Addendum No. 3
February 20, 2023

Project: Harrisburg Elementary School #8
Harrisburg, South Dakota
Architecture Incorporated Project #3000

Scope of this Addendum:

HARRISBURG ELEMENTARY SCHOOL #8
FLOOR PLAN - AREA B

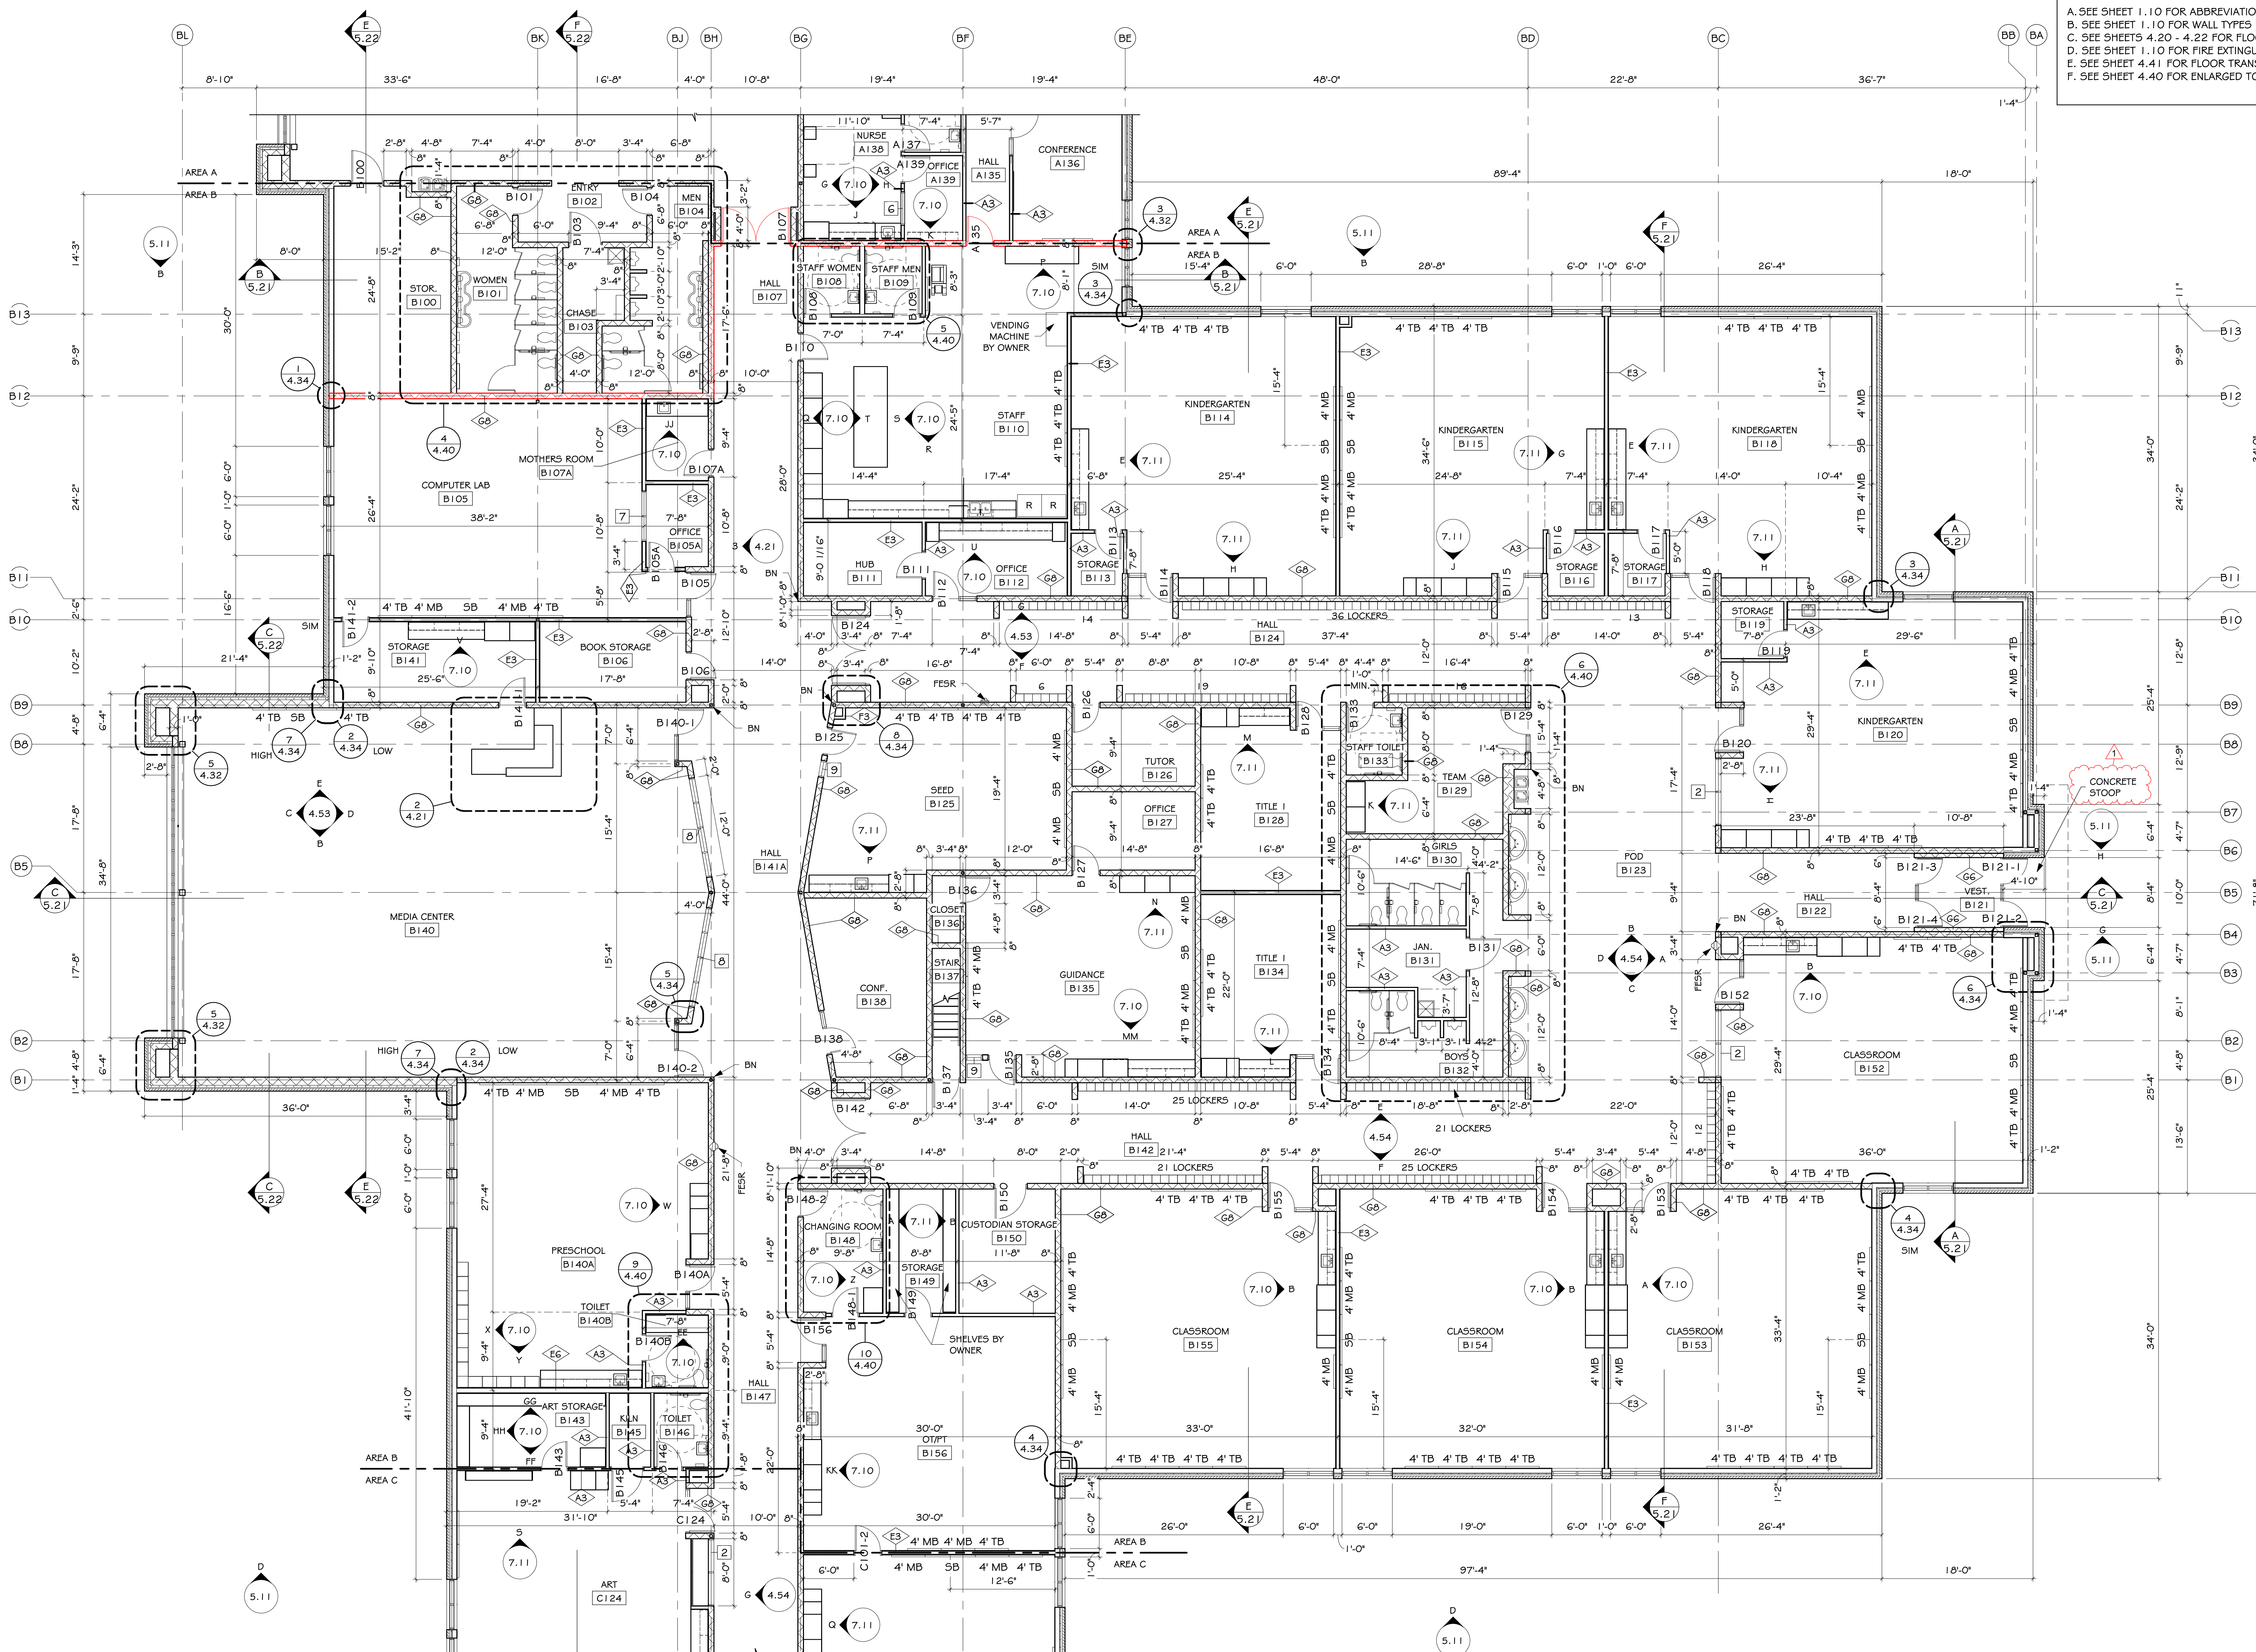
- a) Provide and install sinks in classrooms B152, B153, B154 and B155 as indicated in the *revised* drawing Sheet 4.12, dated 2-20-23, attached to the end of this addendum.
 - i) Revise casework elevation tags as shown; reference Sheet 7.10 for casework elevations A/7.10 and B/7.10.
- b) Depth of all locker wing walls at POD B123, Hall B124 and Hall B142 shall be changed from 2'-0" to 1'-4".
- c) Relocate smartboards in Kindergarten B114, B115, and B118 as indicated in the *revised* drawing Sheet 4.12, dated 2-20-23, attached to the end of this addendum.
- d) Relocate smartboards in Classrooms B153, B154, and B155 as indicated in the *revised* drawing Sheet 4.12, dated 2-20-23, attached to the end of this addendum.

HARRISBURG ELEMENTARY SCHOOL #8
FLOOR PLAN - AREA C

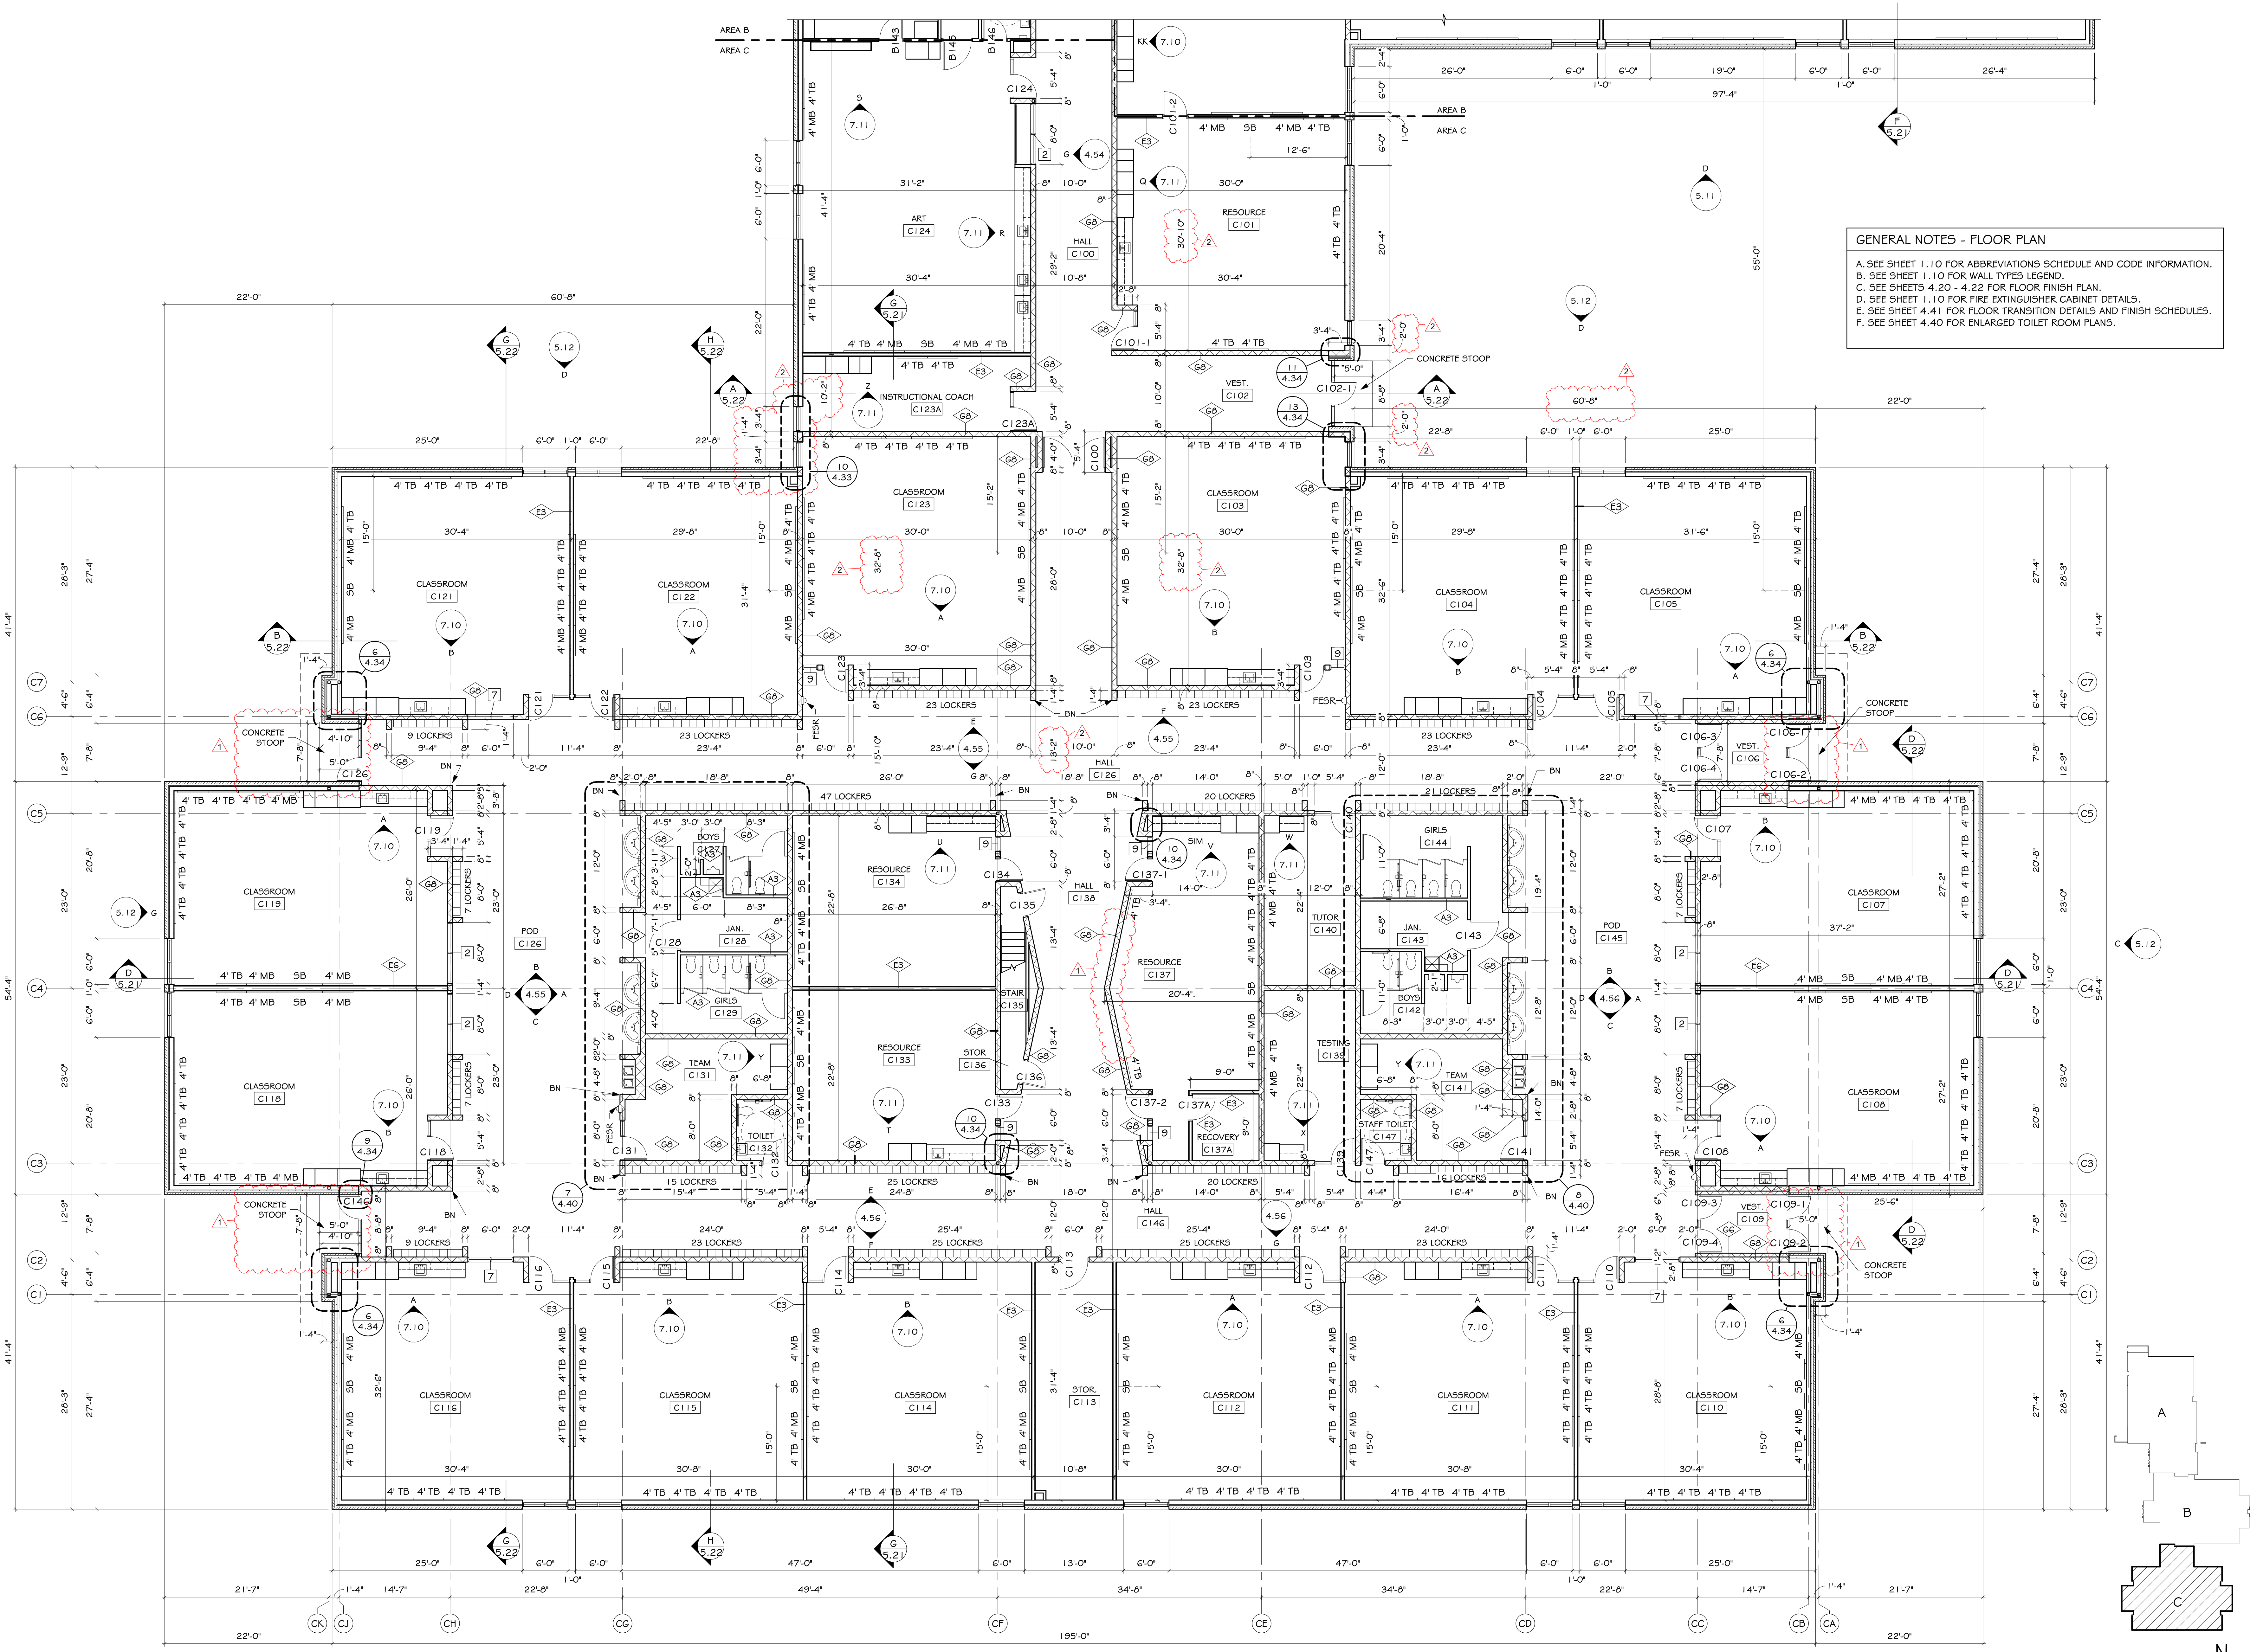
- a) Depth of all locker wing walls at POD C145, POD C126, Hall C126 and Hall C146 shall be changed from 2'-0" to 1'-4".
- b) Add 1'-4" deep, 8" concrete masonry locker wing walls at the end of lockers along the west wall of POD C126, as indicated in the *revised* drawing Sheet 4.13, dated 2-20-23, attached to the end of this addendum.

- i) Adjust location of borrowed lites as shown.
- c) Add 1'-4" deep, 8" concrete masonry locker wings walls at the end of lockers along the east wall of POD C145, as indicated in the *revised* drawing Sheet 4.13, dated 2-20-23, attached to the end of this addendum.

- i) Adjust location of borrowed lites as shown.
- d) Add 1'-4" deep, 8" concrete masonry locker wings at the west end of lockers at Hall C126 and C146 immediately east of Doors C126 and C146 as indicated in the *revised* drawing Sheet 4.13, dated 2-20-23, attached to the end of this addendum.
